CAPITOL HILL

1517 Bellevue Avenue
Multifamily Residential
DPD #3018252

Design Recommendation Meeting
July 22nd, 2015

EDG PREFERRED MASSING

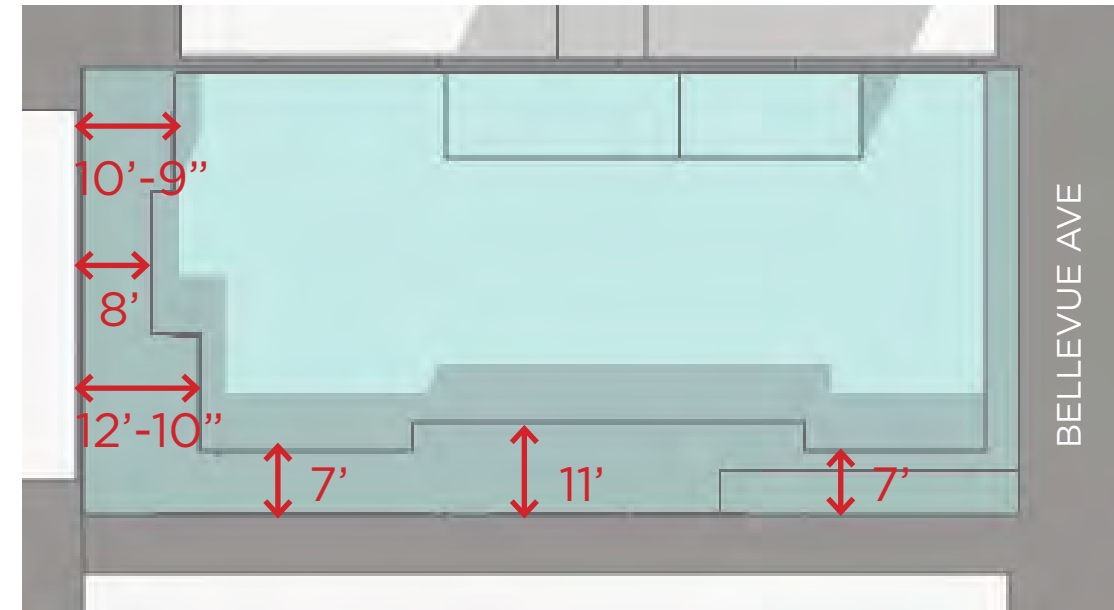
- A. Maintain the layout and setback from the south property line. (CS2.D.5, CS2.IV.iii)

We have maintained the layout and setback shown at the EDG meeting to create a courtyard at the South property line, as well as at the West property line. Please refer to landscape drawings and courtyard pages for a more detail of this outdoor area.

PROPOSED DESIGN

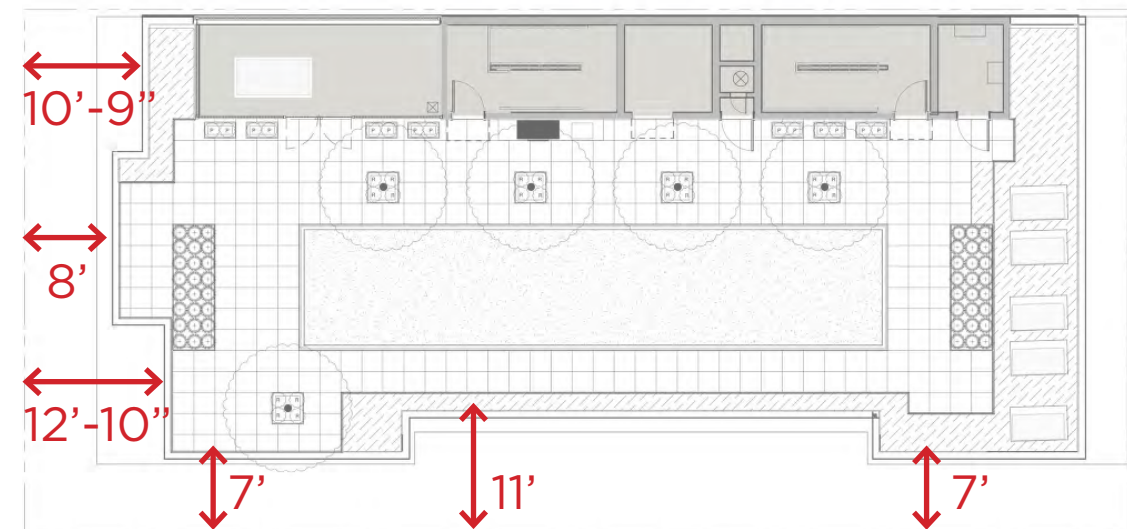
- B. Design a stronger street edge. (CS2.C.2, CS2.IV.i, CS2.IV.ii)

- D. Redesign the northwest corner where the building services are located. (CS2.C.2, CS2.IV.i, PL2.B, DC1.C.4)

We have designed a stronger street edge that spans from property line to property line to better meet the Design Guidelines. Please refer to the response to Recommendation "3. Street Frontage" for a more detailed explanation.

We have redesigned the NW corner to better meet the Design Guidelines. Please refer to the response to Recommendation "3. Street Frontage" for a more detailed explanation.

BICYCLE RACK FEATURE WALL

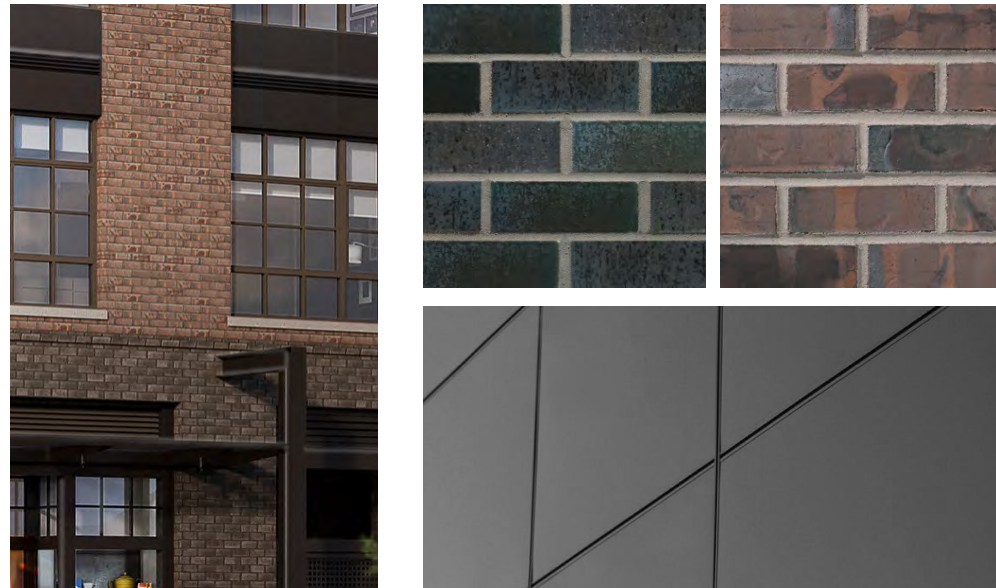
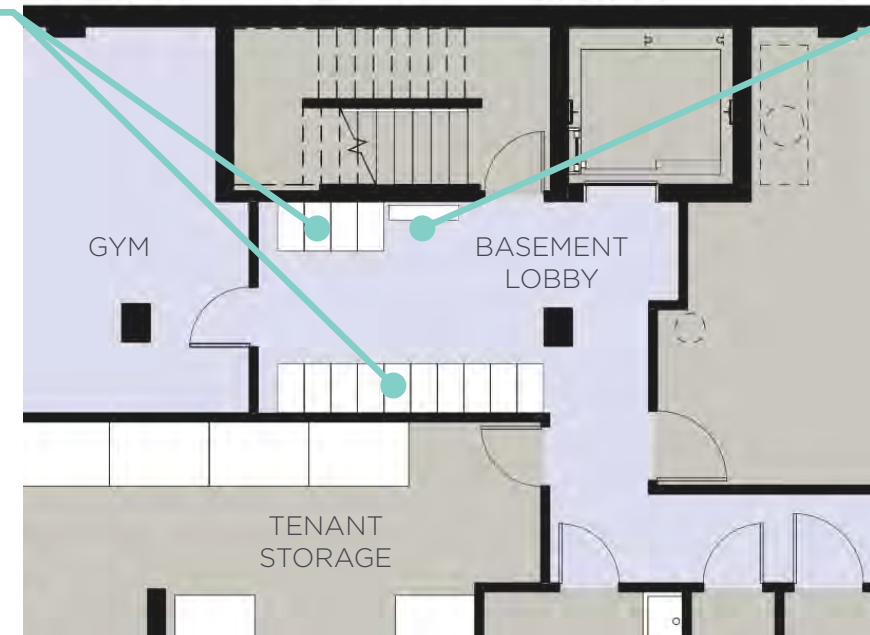
- C. Locate the bike storage area so it has easier access. (PL4.B.2)

The bike storage has been moved out of the basement general storage room. A basement lobby amenity space has been created to highlight the bicycles, bicycle maintenance, and a glazed gym entry. A bike rack feature wall with a work area greets the tenant directly exiting the elevator or stairs from the ground level lobby.

RESIDENTIAL ENTRY GATE

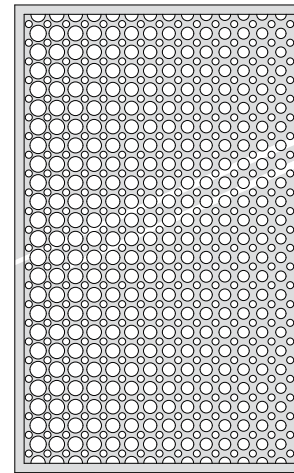
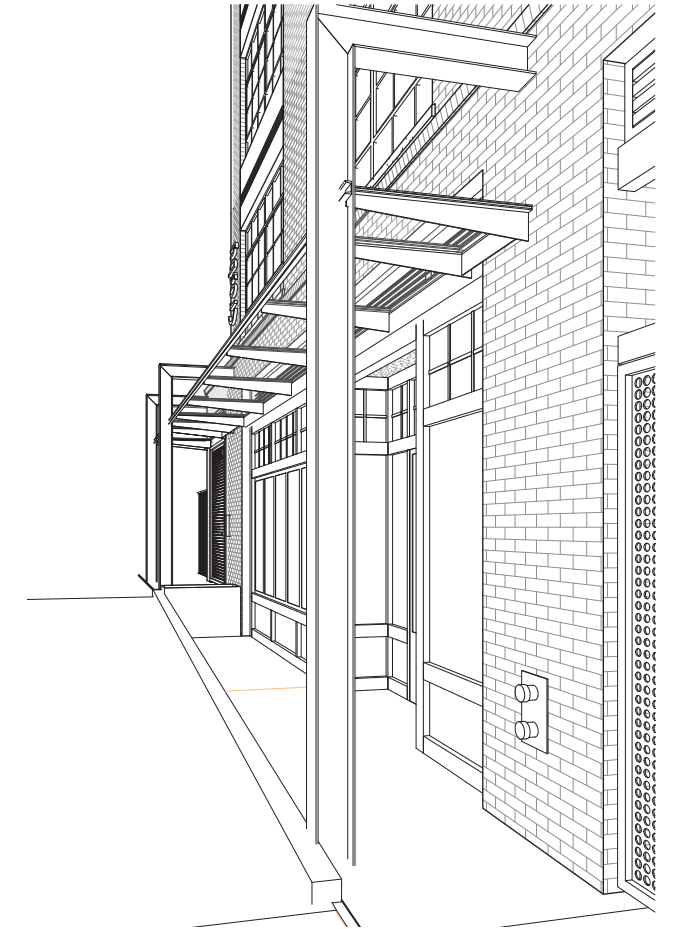
The Board was concerned about the 4' setback from the street property line for the utility manhole. The applicant responded that the manhole needs to be on site near the street facing property line so that access can be from the street. There was concern about the security, aesthetics and functioning of the service entry. The Board noted that a gate in front of the entry is not a solution to the problem. (CS2.C.2, CS2.IV, PL2.B, DC1.C.4)

- A. Design a stronger street edge. (CS2.C.2, CS2.IV.i, CS2.IV.ii)
- B. Diminish the service entry size and provide security for that area that will function and be visually pleasing. (PL2.B, DC1.C.4)
- C. Consider spanning the full width between the side lot lines along the street level. (CS2.C.2, CS2.IV.i, CS2.IV.ii)
- D. Provide transparency along the street edge. (PL2.B.3, PL3.C.2)

In response to the EDG comments, we have eliminated the spine element that was emphasizing the service entry location. We have extended the base of the building to the Southern edge of the property by adding a residential entry portal and stainless steel perforated artistic gate to the community courtyard. The service entry size has been reduced in height and width, and we have added a security gate in dark metal (similar in tone to the dark brick base) mimicking the design of the residential gate. The service gate does not extend fully to the top of the opening, further deemphasizing its importance. We have extended the retail storefront in front of the trash lift by adding a display vitrine. A tree in a planter box is placed in the NE corner to elevate the façade design and to screen the 4 ft of blank side elevation of the neighboring building. We have added a steel arbor extending 4ft from the façade to the property line. The arbor, which supports a glass and metal canopy, extends over the retail storefront and residential entry only (not the service entry). This covered outdoor area creates a space for residents to find keys before entering the courtyard, and for retail customers to enjoy street seating.

ADJACENT BUILDING WINDOW OVERLAY

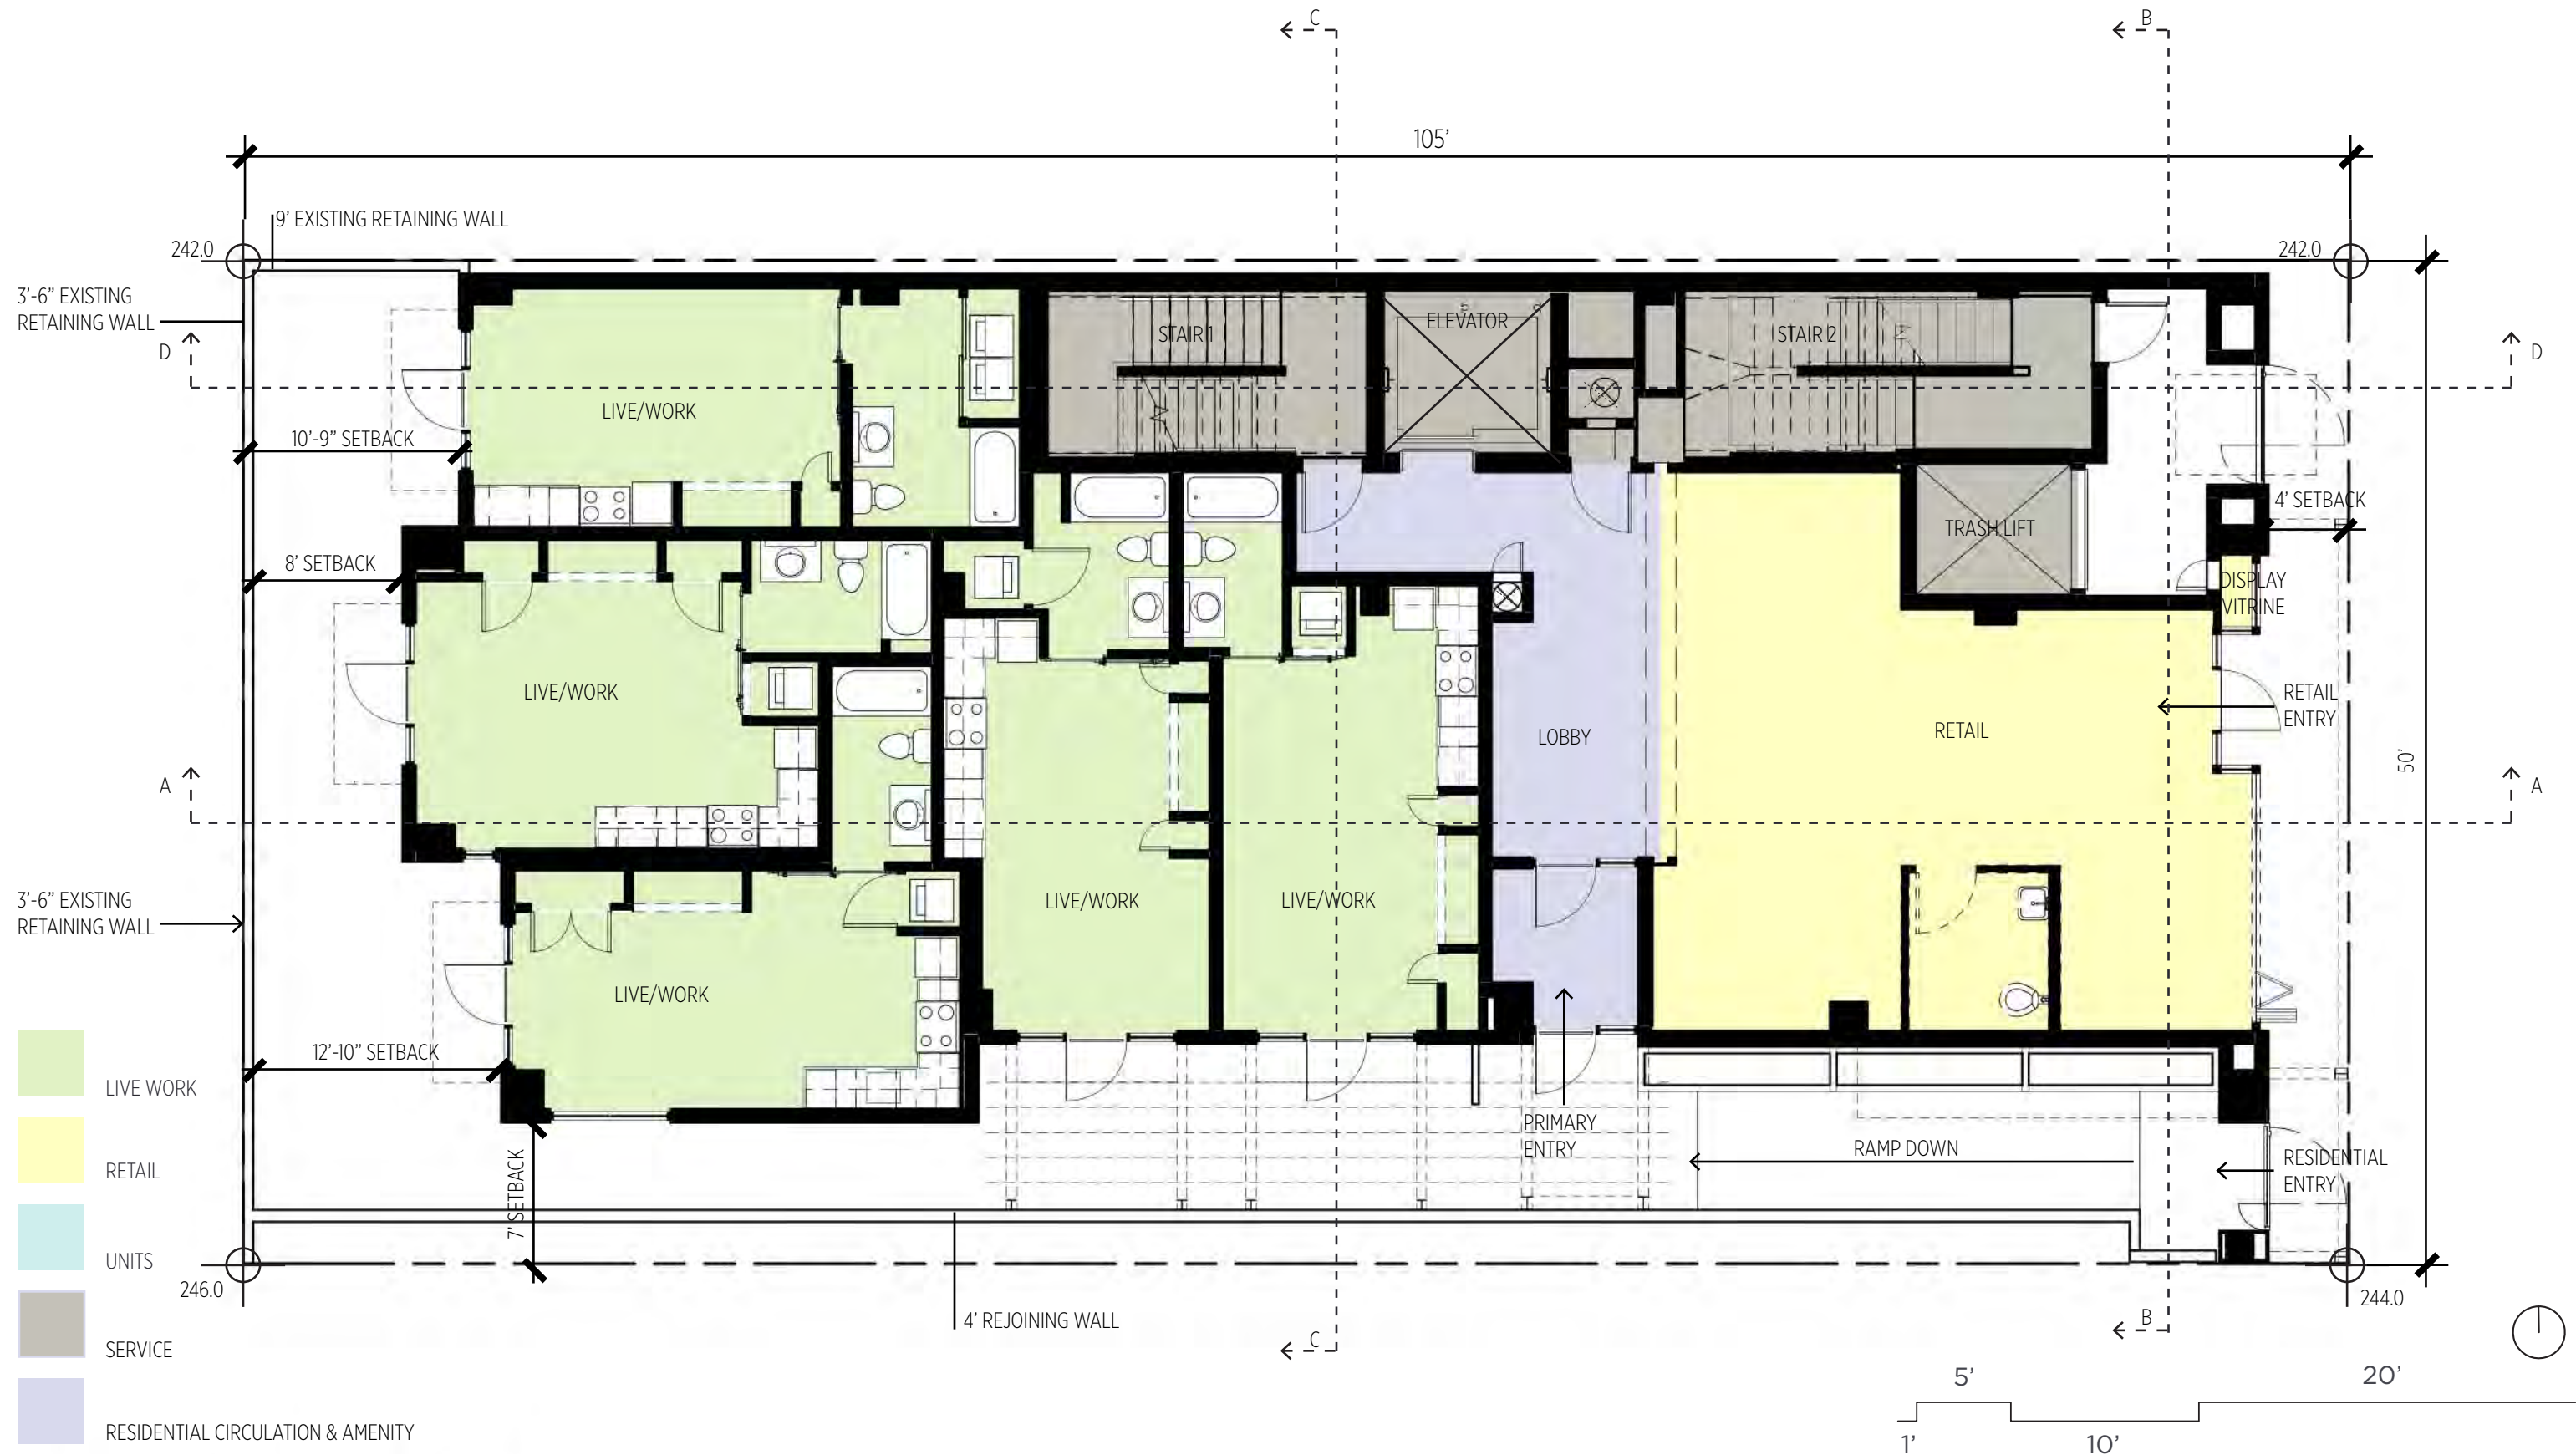
- B. Consider the location of the windows of the existing building to the south when designing the courtyard and landscaping. (CS2.D.5, CS3.I)

We have mapped the windows of the existing building to the South. The design calls for 10 Columnar Norway Maples to be planted between the two properties to create privacy for both buildings' residents.
